MIL-C-11693C
AMENDMENT 4
6 AUGUST 1982
SUPERSEDING
INT. AMENDMENT 3(ER)
16 June 1981
USED IN LIEU OF
AMENDMENT 1
28 March 1977

MILITARY SPECIFICATION

CAPACITORS, FEED THROUGH, RADIO-INTERFERENCE REDUCTION, AC AND DC
(HERMETICALLY SEALED IN METAL CASES),
ESTABLISHED AND NON-ESTABLISHED RELIABILITY
GENERAL SPECIFICATION FOR

This amendment forms a part of Military Specification MIL-C-11693C, dated 8 October 1971, and is approved for use by all Departments and Agencies of the Department of Defense.

FIGURE 1. Insulation-resistance curve for characteristics - M, -K, -E, and -W.

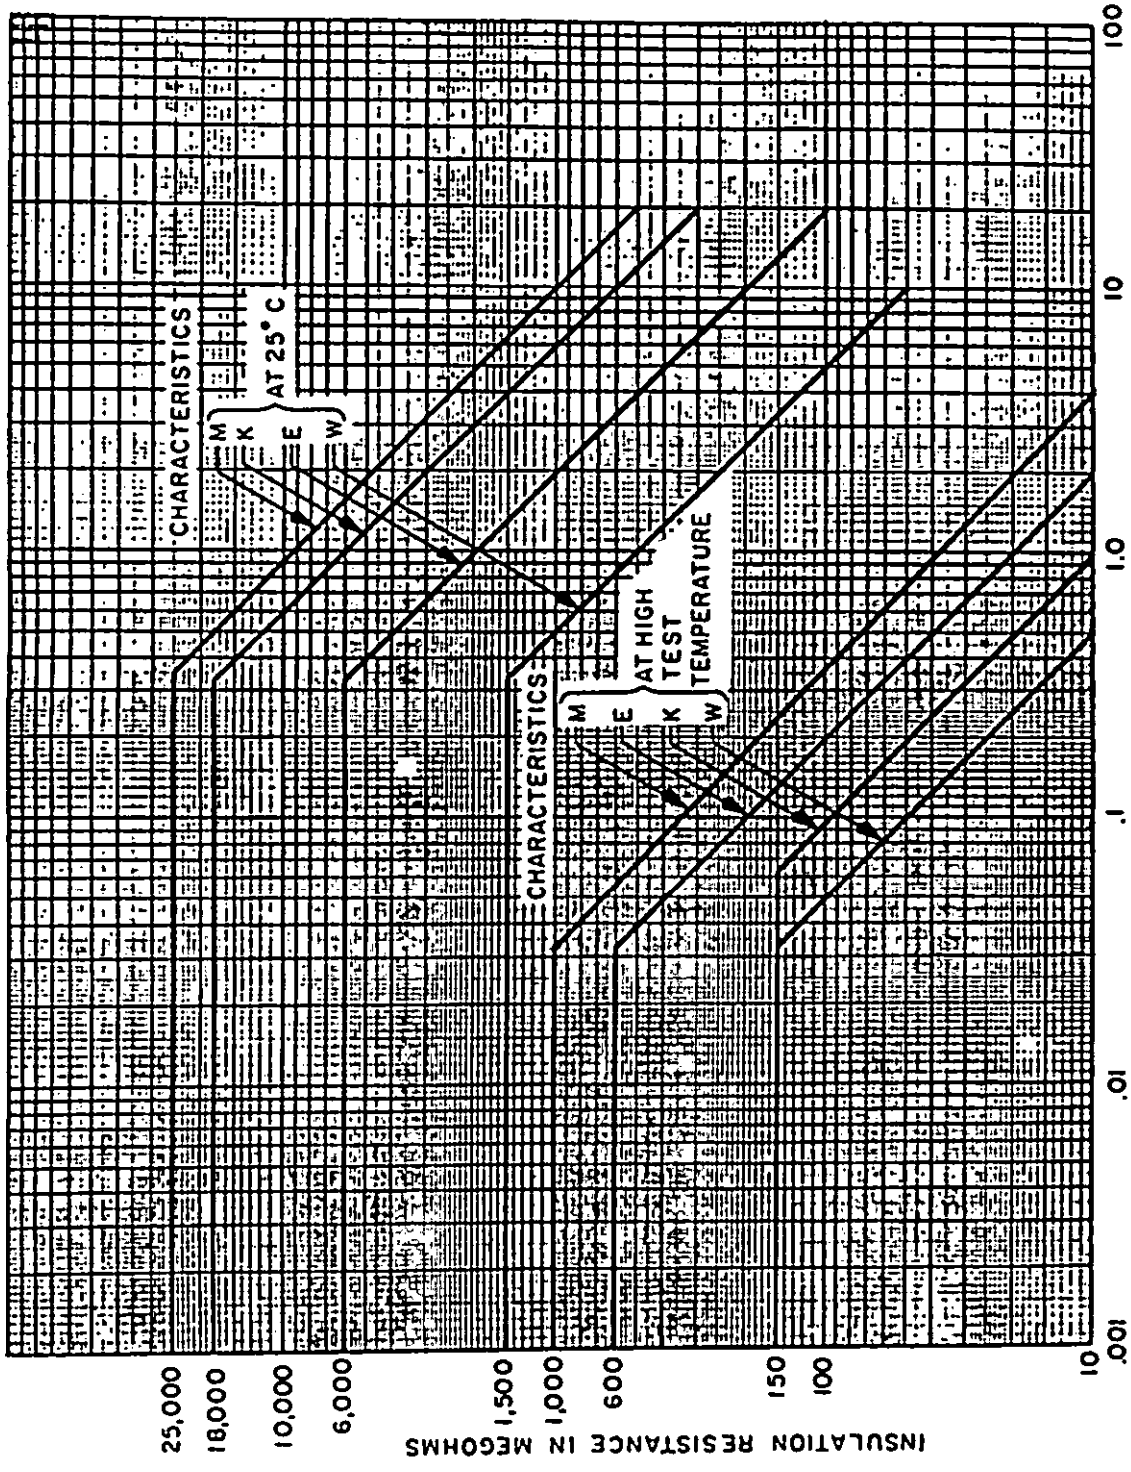
FIGURE 1: Delete and substitute new figure 1 as printed on page 3 of this amendment.
